5.1 NO. 128A (LOT: 2; STR: 80812) HAROLD STREET, MOUNT LAWLEY - PROPOSED ALTERATIONS AND ADDITIONS TO SINGLE HOUSE

PURPOSE OF REPORT:

To consider an application for development approval for alterations and additions to an existing single house at No. 128A Harold Street, Mount Lawley (the subject site).

Project Number: 2020-22 Drawing Number: A2.01

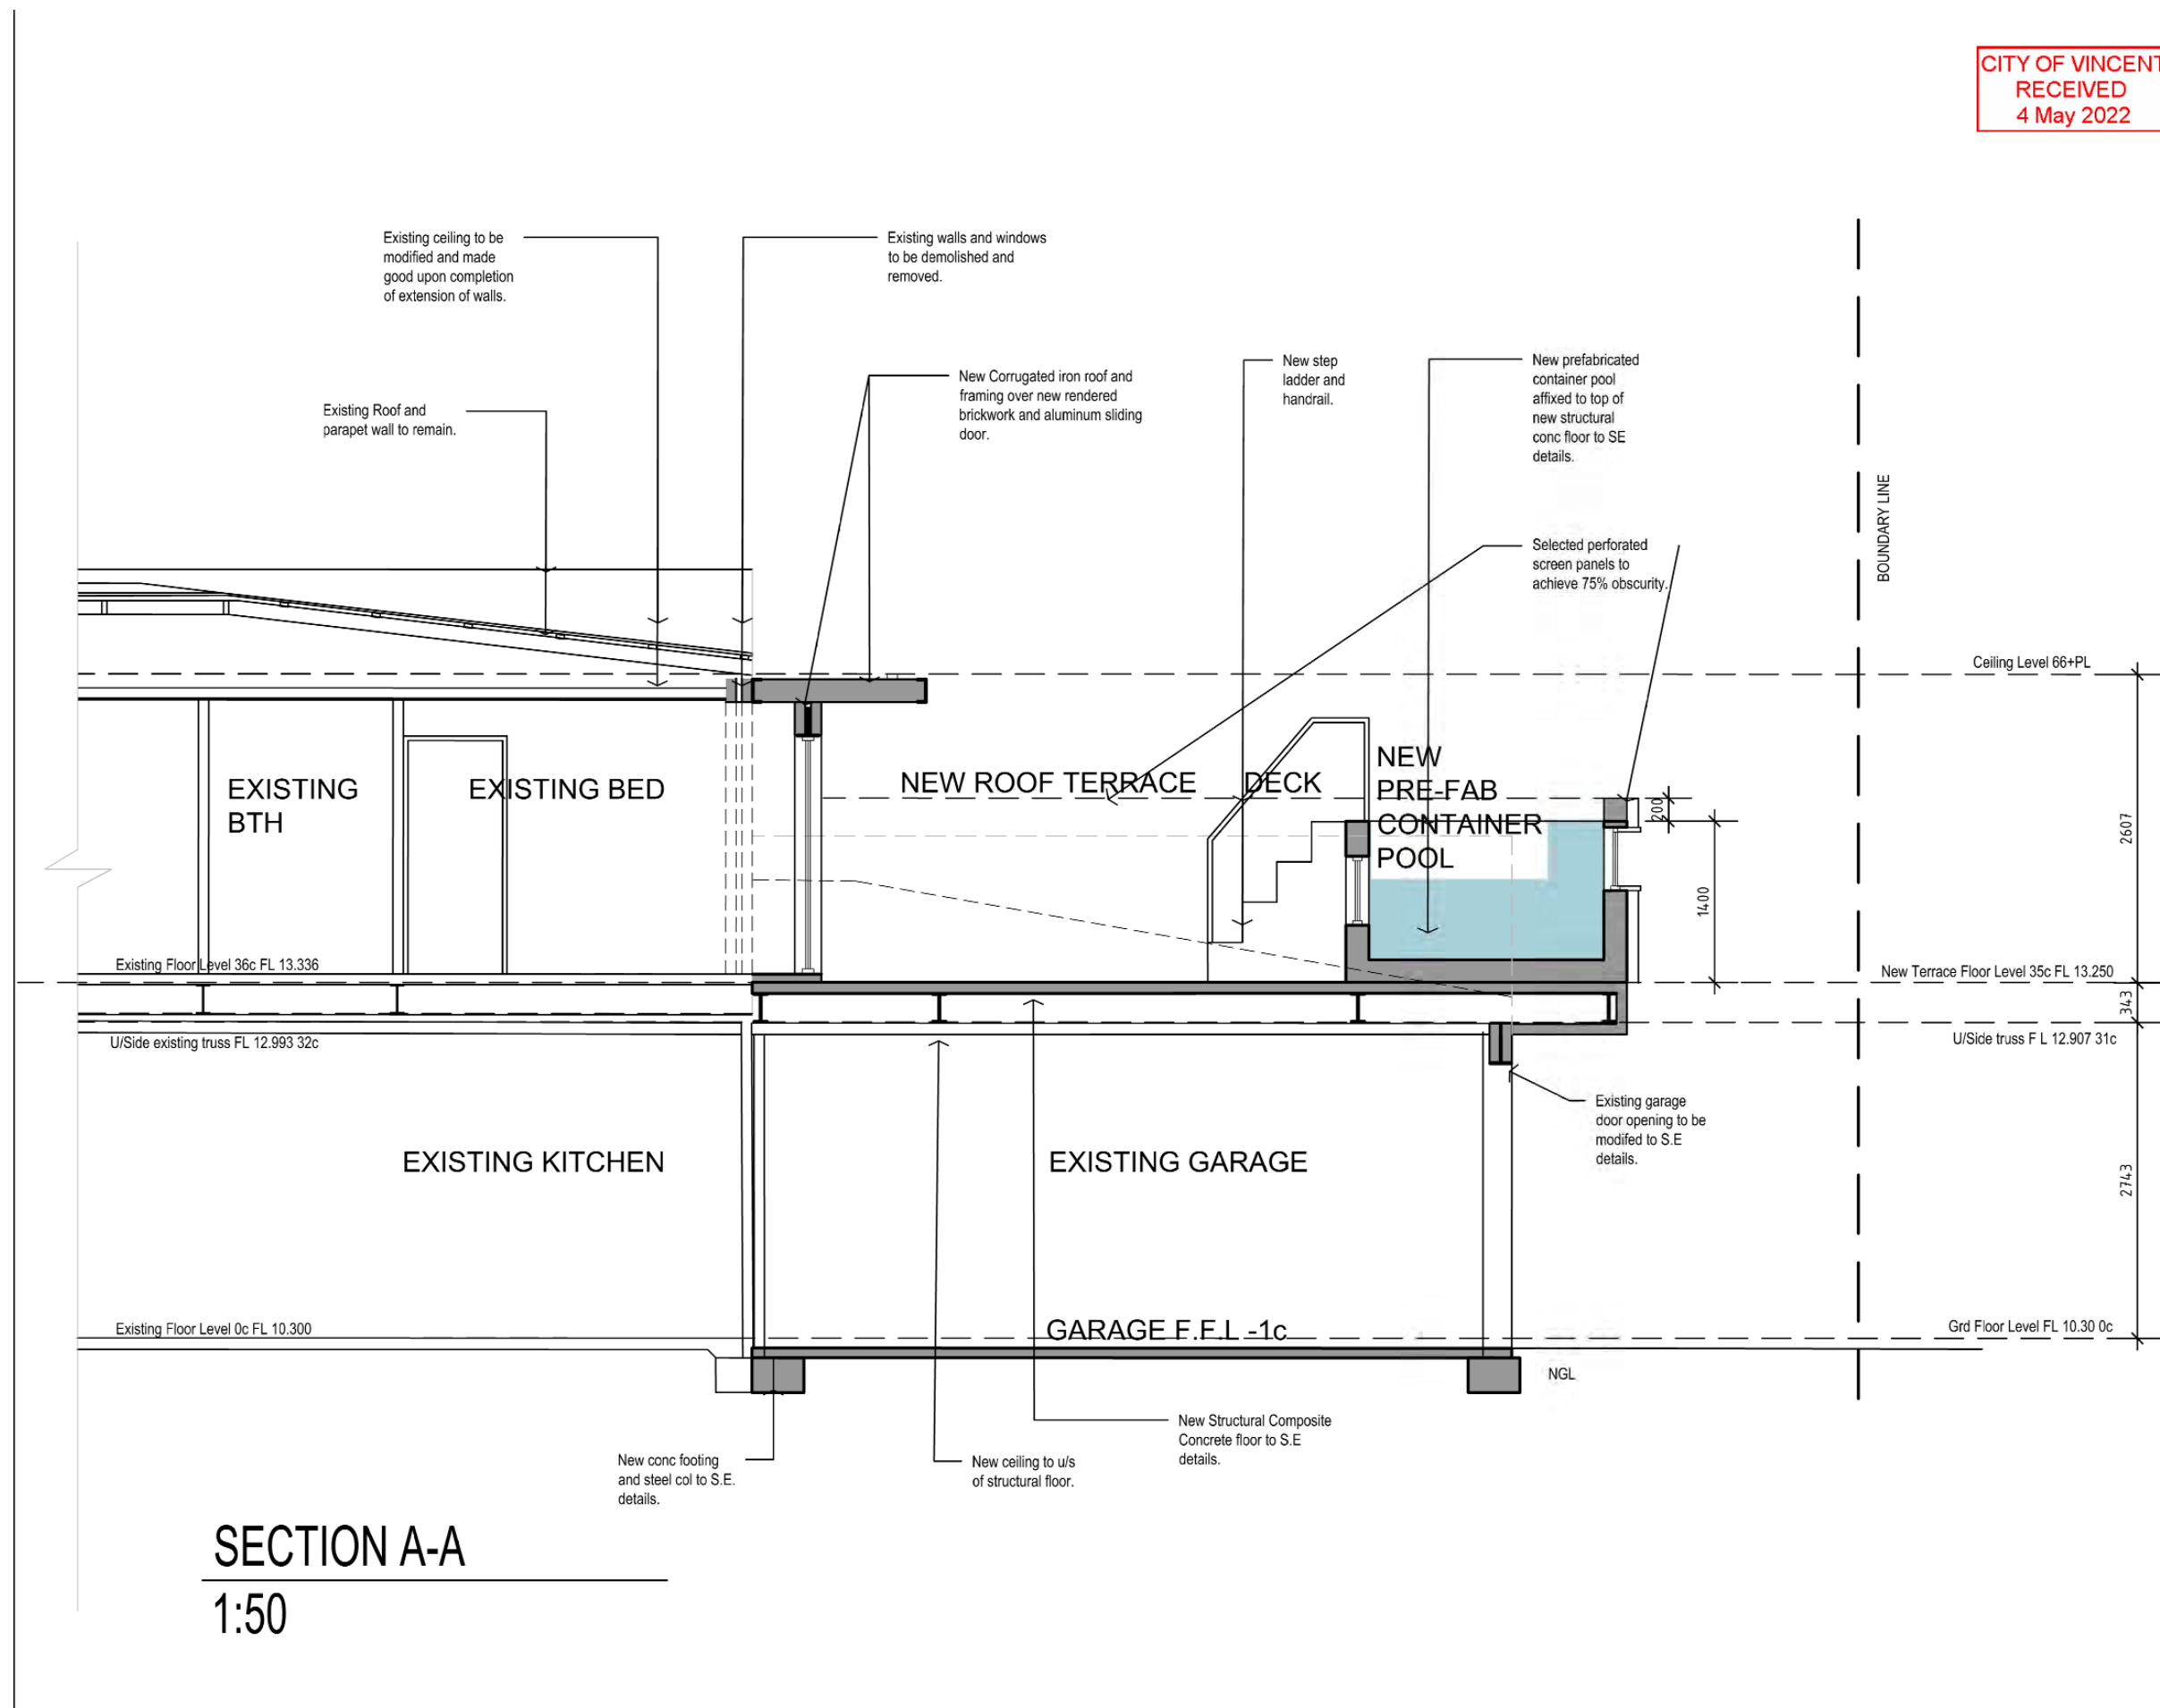
The R Codes deemed-to-comply standard sets out the wall on the first floor to be setback 2.3 metres from the south eastern lot boundary. This has reduced from 2.6 metres due to the removal of the skillion roof patio which had a maximum height of 7.1 metres and that was previously proposed.

A privacy screen is being proposed to the south east of the first floor terrace that would be on top of an existing wall. This privacy screen would measure 7.0 metres in length and 1.6 metres in height above the terrace finished floor level. The privacy screening is setback 1.1 metres from the south eastern lot boundary.

The privacy screen addition connects to a proposed 0.6 metre extension to the existing upper floor bedroom used to access the pool terrace area. This wall would reach a total height of 6.2 metres and is also setback 1.1 metres to the south eastern lot boundary. The remainder of the existing dwelling first floor wall to this south eastern boundary is 11.9 metres in length, 6.6 metres in height and setback 1.1 metres.

- Mitigating Building Bulk:
 - The top of the privacy screen would be 5.1 metres in height measured from natural ground level which is 1.5 metres less than the existing south eastern first floor wall of the dwelling that it would adjoin. The stepping down of height would assist in reducing the impact of the building bulk associated with the first floor wall to the south eastern adjoining property;

- Visual Privacy:
 - The proposed privacy screening is 1.6 metres in height measured from the terrace floor level. This would restrict views from the terrace area to the adjoining properties and complies strictly with the deemed-to-comply standards of the R Codes in relation to visual privacy. A condition of approval has been recommended requiring privacy screening to be installed prior to use of the terrace area;

- Following the deferral of the application by Council at its meeting on 5 April 2022, the applicant submitted amended plans which include a 0.3 metre wide planter box along the inside south eastern edge of the roof terrace to provide separation between the usable area of the roof terrace and the south eastern adjoining property. The setback of the usable area of the roof terrace to the south eastern lot boundary would now be 1.5 metres; and

Project: **PROPOSED ADDITIONS TO EXISTING HOUSE**
 Location: 128A HAROLD ST MT LAWLEY
 Title: **NORTH ELEVATION**
 Project North:

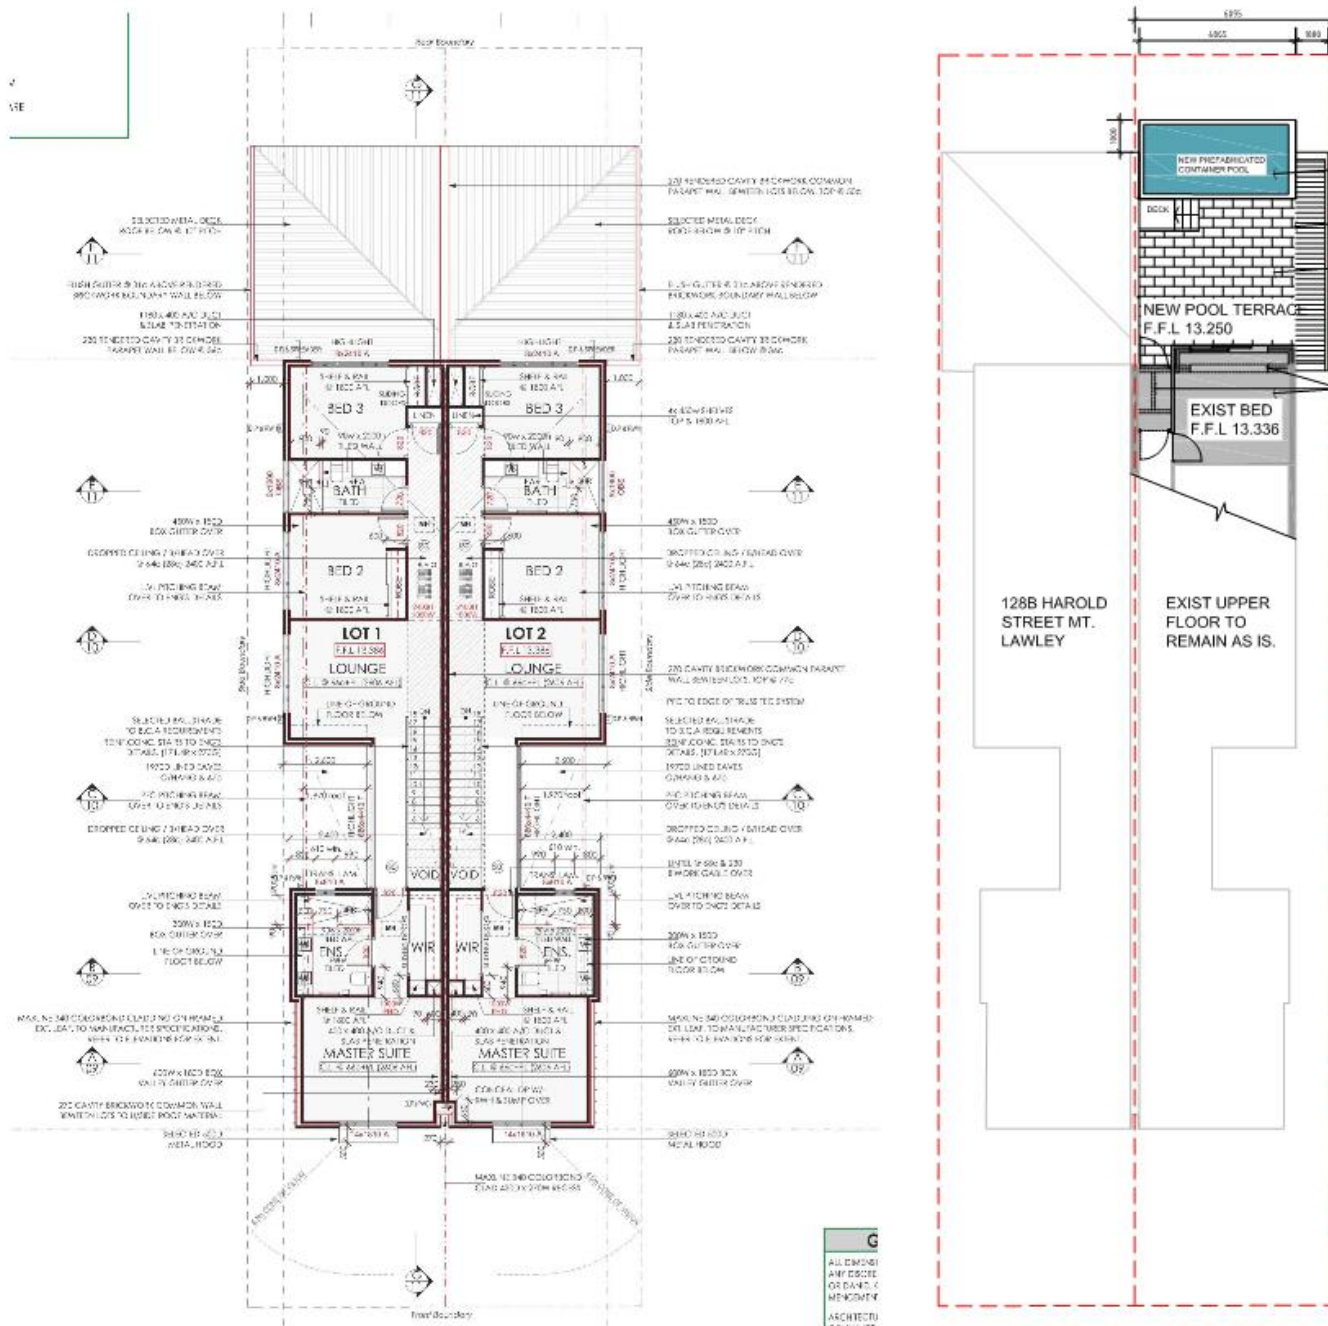
The privacy screen proposed to the north west of the first floor terrace is 7.6 metres in length and has maximum height of 5.1 metres above natural ground level, resulting in a 0.3 metre increase to the existing boundary wall height for this portion of the boundary. The proposed privacy screen to the first floor terrace would extend the existing boundary wall along the north western lot boundary by 7.6 metres to a total boundary wall length of 31.3 metres.

Following deferral of the application by Council at its meeting on 5 April 2022, the applicant submitted the amended plans included in **Attachment 2** which reduced the proposed boundary wall height to the north western lot boundary by 1.0 metre, from the maximum height of 6.1 metres that was previously proposed.

- Mitigating Building Bulk:
 - The boundary wall extension would abut the garage of the adjoining property to the north-west. This would limit the impact associated with building bulk, as this area is void of any habitable rooms and living spaces; and

- Following deferral of the application by Council at its meeting on 5 April 2022, the applicant submitted amended plans which removed the previously proposed raised deck area at the top of the stair access to the pool, further reducing opportunities for perceived overlooking to adjoining properties.
